SUPPLEMENTAL WRITTEN TESTIMONY OF

DR. RICHARD T. LAHEY, JR.

REGARDING CONTENTIONS

NYS-25, NYS-26B/RK-TC-1B, AND NYS-38/RK-TC-5

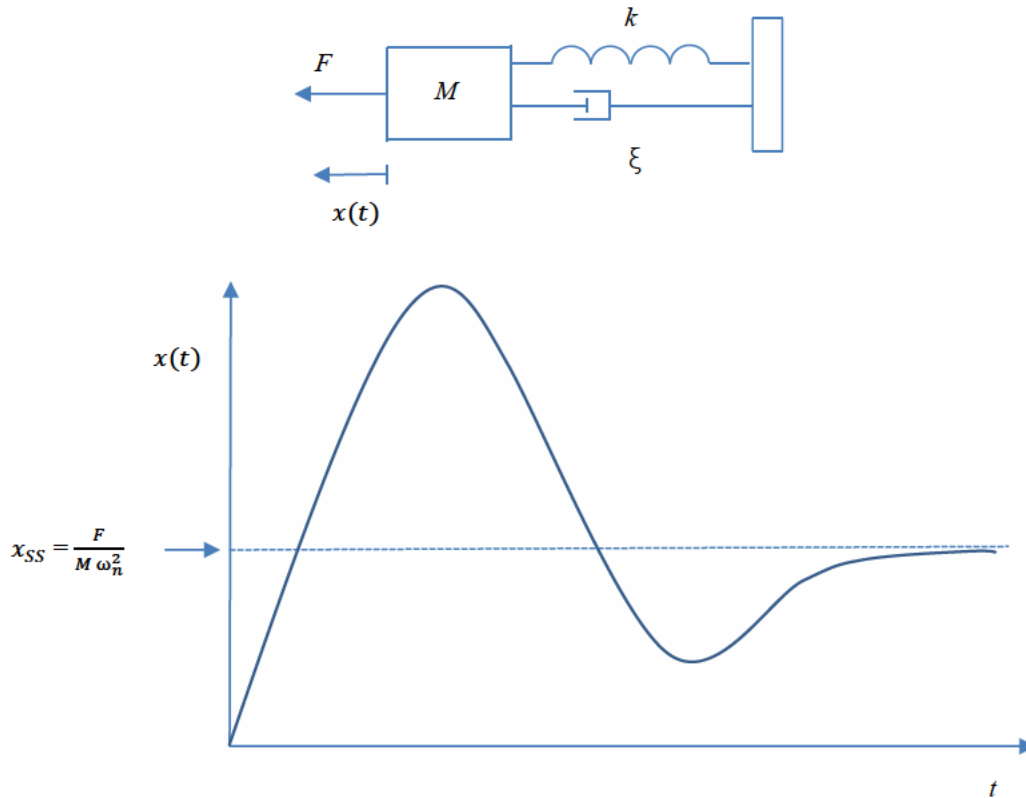
20 For this type of impulsive forcing function, an underdamped
21 system, such as the baffle/bolting complex in a PWR, responds as
22 shown schematically in the hand-drawn diagram I prepared during

1 the November 2015 evidentiary hearing (exhibit NYS000582). For
2 convenience, I have reproduced this schematic below:

3 Note that there will be significant inertial overshoot of
4 the displacement, $x(t)$ before it returns to an equilibrium
5 (steady-state) displacement, x_{SS} . This figure shows a
6 hypothetical situation in which the ΔP is maintained constant,
7 while for a PWR the impulsive forcing function will be more like
8 that associated with a Dirac delta function, $F = \Delta P A \delta(t)$.
9 However, the initial inertial overshoot will be similar to the
10 step change solution but the solution will finally return to its

1 original state, $x_{ss} = 0.0$. Naturally, the smaller the size of the
2 pipe break, the less the inertial overshoot. Additionally, if
3 the $\Delta p(t)$ occurs over a finite period of time (Δt) [REDACTED]
4 [REDACTED],
5 the induced overshoot for these ramps (as opposed to steps) in
6 $\Delta p(t)$ will also be reduced. In any event, the magnitude of the
7 transient overshoot in the displacement, $x(t)$ of the structure
8 determines the maximum strain (and stress) that the structure is
9 exposed to. Because the baffle-former bolts during the period of
10 extended operations will be highly fatigued and embrittled,
11 their stress-strain curve will initially be quite steep (i.e.,
12 the linear elastic part will have a large slope due to
13 irradiation-induced hardening), and the ultimate stress (which
14 for highly embrittled stainless steel bolts will be almost the
15 same as the yield stress) will be larger than for a
